GROUP	MODEL
BOD	2021-2025MY Sorento (MQ4a) <u>and</u> 2021-2025MY Sorento Hybrid (MQ4 HEV) <u>and</u> 2022-2025MY Sorento Plug-in Hybrid (MQ4 PHEV)
NUMBER	DATE
351	March 2026

## TECHNICAL SERVICE BULLETIN

SUBJECT: **HORN ASSEMBLY INSPECTION AND REPLACEMENT (WTY042)**

**This issue number is WTY042.**

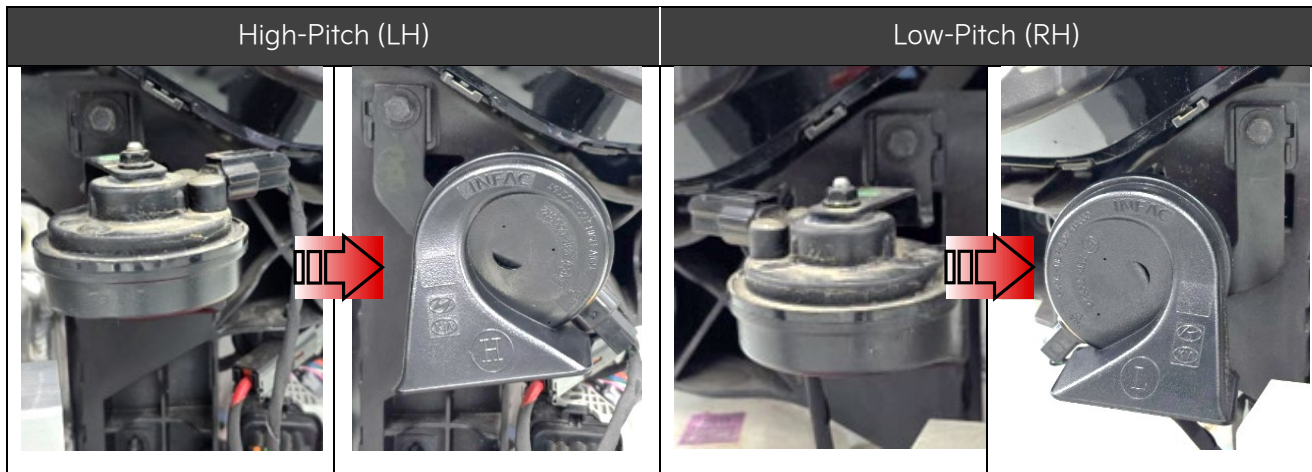
For 24-25MY MQ4a and 25MY MQ4 P/HEV, the replacement horns will install in a vertical orientation, which differs from the original mounting position.

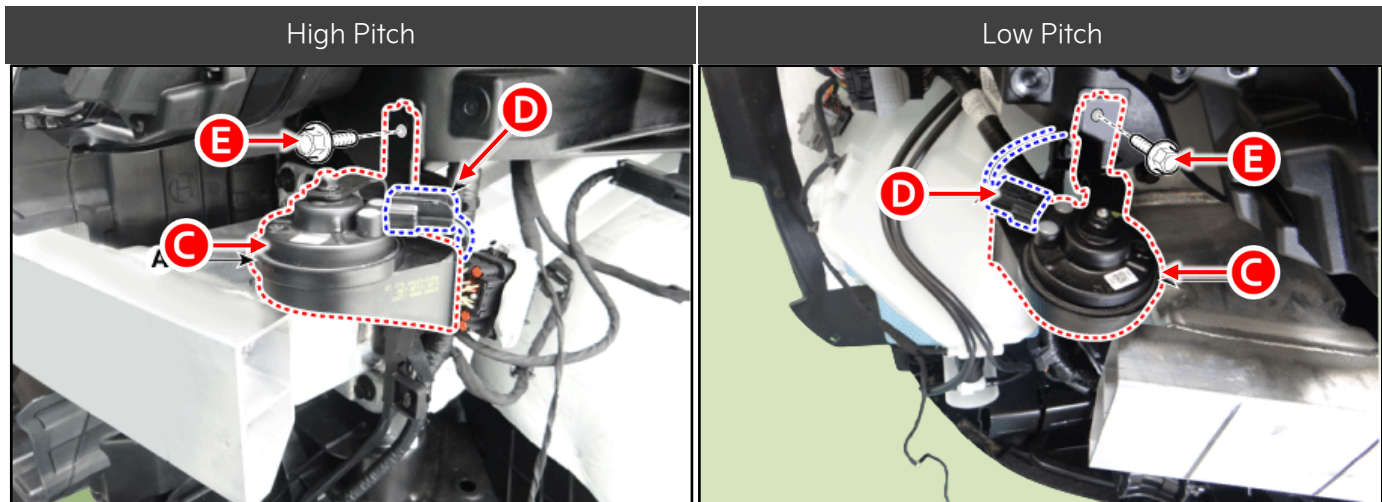
- Replace the low pitch and high pitch horns (C) after disconnecting the horn connector (D) and removing bolt (E) by referring to "Body Electrical System → Horn → Repair procedures" in the applicable Shop Manual on KGIS.

**Tightening torque for nut/bolt (E):**  
8.2 - 9.0 lb.ft (11.1 - 12.3 N.m)
